# United States Patent and Trademark Office

This is the first Office Action for application number 10/626,101, Suction-Adhesive Device, filed on 7/23/03. Claims 1-20 are pending. This application claims priority to Hong Kong Reg. 02105663, dated 8/1/02 and Hong Kong Reg. 03102213.4, dated 3/26/02.

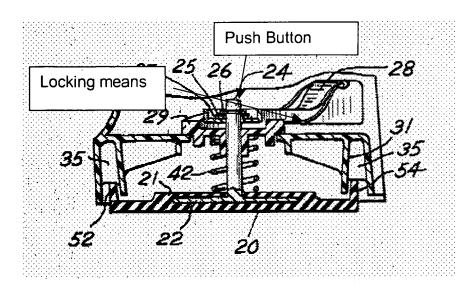
Claims 1-6, 9-14 and 17-20 are rejected under 35 U.S.C. 102(b) as being anticipated by United States Patent No. 3747170 to Kieves.

The patent to Kieves discloses a suction cup (20), a stem (24) extending from the suction cup (20) with a pushbutton (tip of 24, See Drawing), a body (21) having a neck through which the stem extends, a spring (42) interacting with the stem and the body, and a visual indicator ring of contrasting color (26) which protrudes beyond the neck of the body when the spring has drawn the suction cup (20) toward the body (21), the washer may be a different color metal than the stem) fixed and integral with respect to the stem, a locking means (28, 29, 32 See Drawing Below) interacting with the body and interacting with the locking means (28, 29, 32).
